**6th Edition (2017) Update to the
Florida Building Code
Proposed Code Modifications**

Mechanical

Proposed Code Modifications

Including Comments

Responsible Energy Codes Alliance Comment on Proposal EN6820

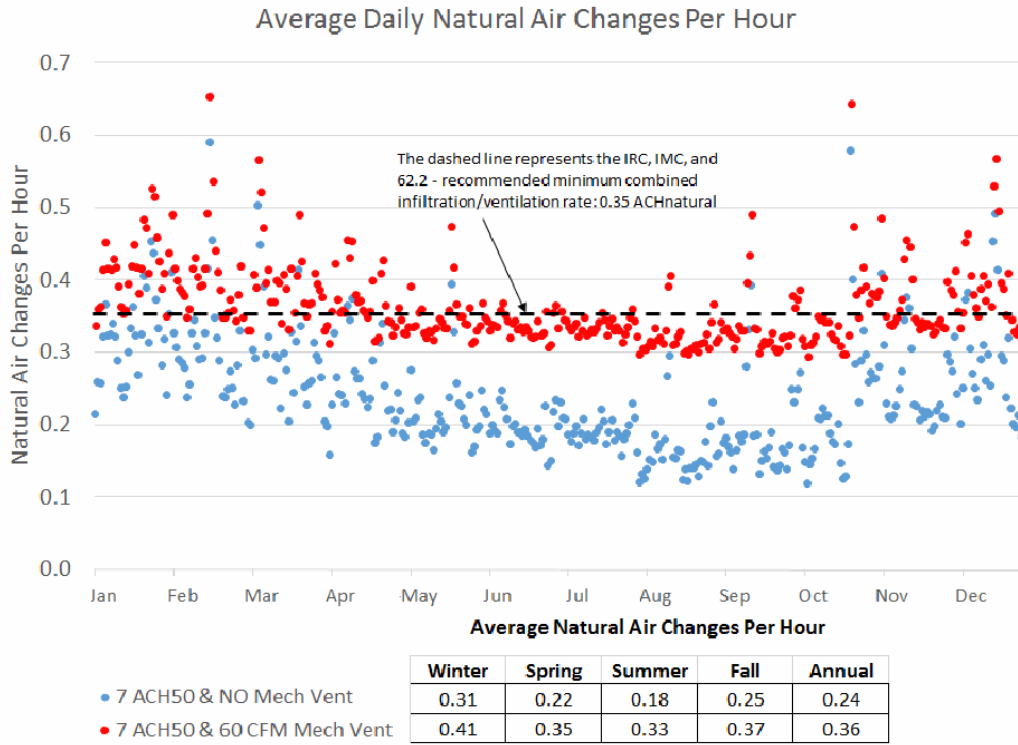
Proposal EN6820 should be disapproved for lack of compelling evidence that any problem or risk is created with use of a 5 ACH requirement. In fact, the risk will likely be worsened by increasing to 7 ACH without mechanical ventilation still being required (see data provided by separate comment from Mike Moore). So, even with this proposal the risks, to the extent they actually exist, will still exist and not be solved and may be worsened by this proposal. As the referenced FSEC study indicates...people will still not maintain and operate ventilation systems properly, installers will not install them properly, inspectors not inspect them adequately, and many homes will still be built tighter than 5 ACH. Thus, this issue is not one of changing the ACH target (which comes with energy penalties and potential moisture control and IAQ problems with no guarantee of any improvement in indoor air quality or moisture control risks). The FSEC study indicates or admits a hope that moving from ACH 5 to ACH 7 “may reduce risk” but gives no risk-based evidence to support that recommendation. This subjective “hunch” does not provide adequate justification for the proposal.

To insure that occupants are able to receive the *minimum* combined infiltration and ventilation rate promulgated by model codes and standards (i.e., 0.35 natural air changes per hour), the air leakage target should not be increased without simultaneously requiring mechanical ventilation. This comment proposes to continue to require mechanical ventilation if Florida elects to increase the air tightness target to 7 ACH50.

Following is a chart created using DOE's EnergyPlus software that shows the average daily combined infiltration and ventilation rate for a typical 2,600 ft² three-bedroom, single-family home located in Orlando. The chart examines daily, seasonal, and annual average combined infiltration and ventilation rates for the same typical home across two scenarios:

Under Scenario A (7 ACH 50 with no mechanical ventilation), the average annual air change rate is 0.24 natural air changes per hour, frequently dipping below 0.15 in the summer months. Research has shown that formaldehyde emissions from building materials increase with increasing temperature and relative humidity, and formaldehyde concentrations increase with decreasing infiltration/ventilation rates. In other words, formaldehyde emissions and concentrations are likely to spike in the summer under Scenario A when natural infiltration is at its lowest. Resultant poor indoor air quality can significantly diminish occupants' health. In fact, research suggests that poor IAQ is responsible for around \$500 annually in health related costs per person in the U.S., which translates to \$10 billion annually in Florida.*

Under Scenario B, as proposed by this comment, tightening the building envelope to 7 ACH50 and providing mechanical ventilation would achieve the minimum annual average combined infiltration and ventilation rate of 0.35 natural air changes per hour. Scenario B would also provide more balanced ventilation across the year, registering 0.33 natural air changes per hour in the summer and providing more protection to occupants from higher levels of formaldehyde expected to be experienced during this season.

Figure above based on flow coefficient (C) calculated based upon assumed flow exponent =0.63, and specified house tightness (ACH50); C. Withers.

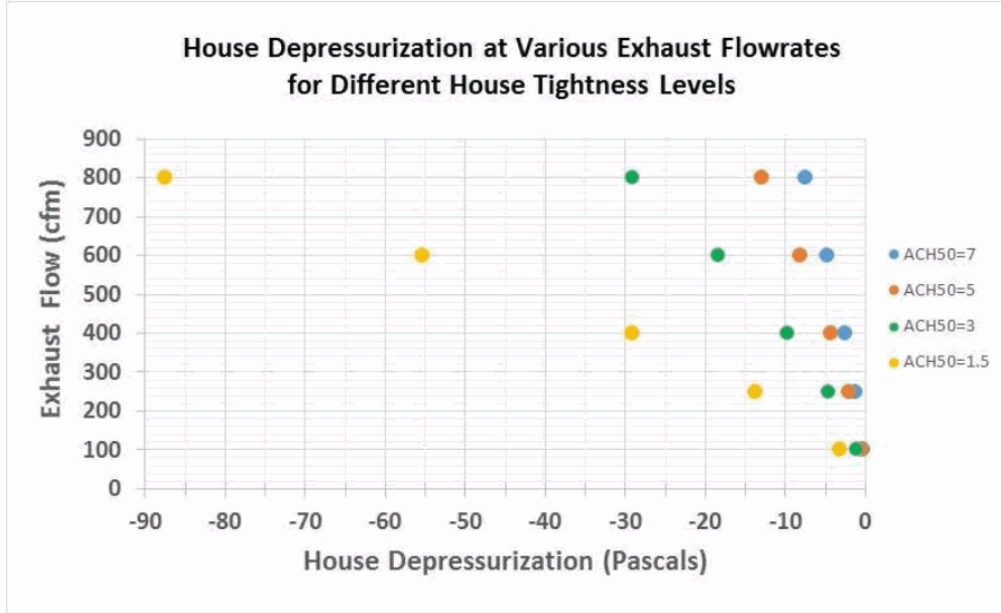
Tighter homes result in greater pressure differentials indoors with reference to outdoors (see figure in supporting file) when mechanical fans move air across the building envelope. This modification will diminish health and safety risks associated with significant depressurization.

M6819-G2

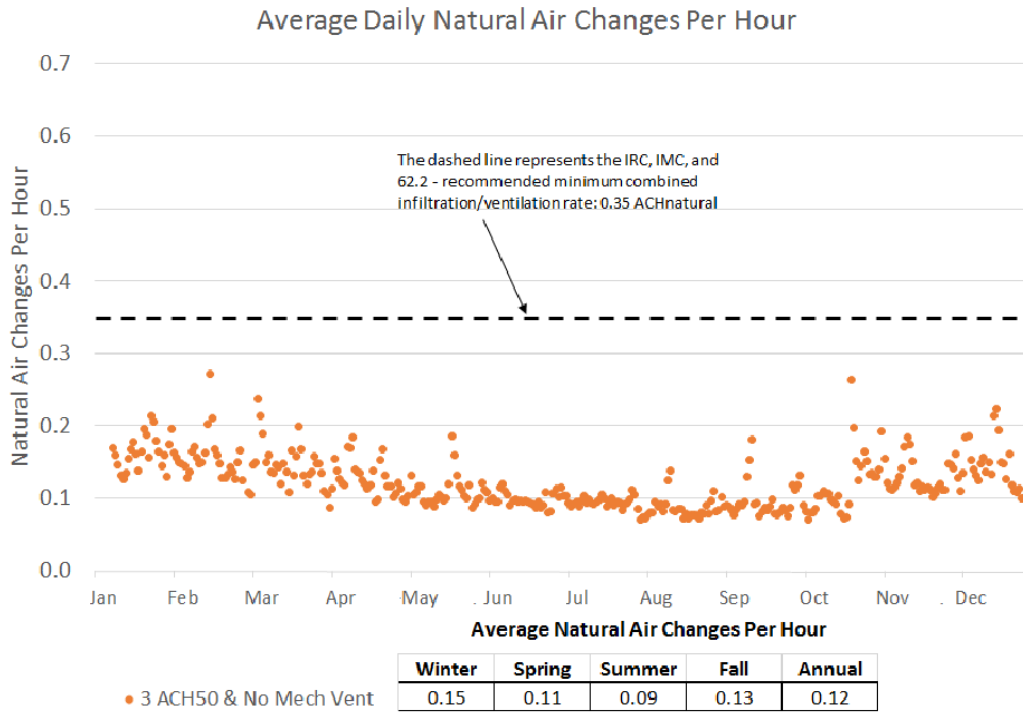
M 6819: Rationale to Disapprove

As an example, following is a chart created using DOE’s EnergyPlus software that shows the average daily combined infiltration and ventilation rate for a typical 2,600 ft² three-bedroom, single-family home located in Orlando with a building air tightness of 3 ACH50 and *no* mechanical ventilation, as proposed by the proponent. The average annual natural air change rate for this typical home is 0.12 (roughly a third of the 0.35 air changes per hour promulgated by model codes and standards), with a seasonal low of 0.09 in the summer. Research has shown that formaldehyde emissions from building materials increase with increasing temperature and relative humidity, and formaldehyde concentrations increase with decreasing infiltration/ventilation rates. In other words, formaldehyde emissions and concentration are likely to spike in the summer when natural infiltration is at its lowest. Resultant poor indoor air quality can significantly diminish occupants’ health. In fact, research suggests that poor IAQ is responsible for around \$500 annually in health related costs per person in the U.S., which translates to \$10 billion annually in Florida.*

Figure above based on flow coefficient (C) calculated based upon assumed flow exponent =0.63, and specified house tightness (ACH50); C. Withers.

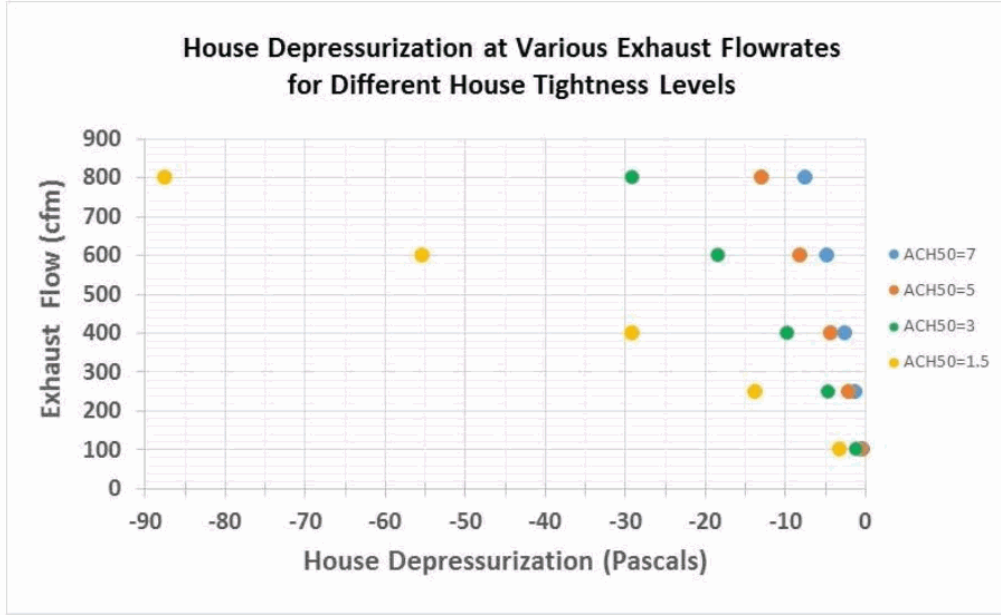
Tighter homes result in greater pressure differentials indoors with reference to outdoors (see figure in supporting file) when mechanical fans move air across the building envelope. This modification will diminish health and safety risks associated with significant depressurization.
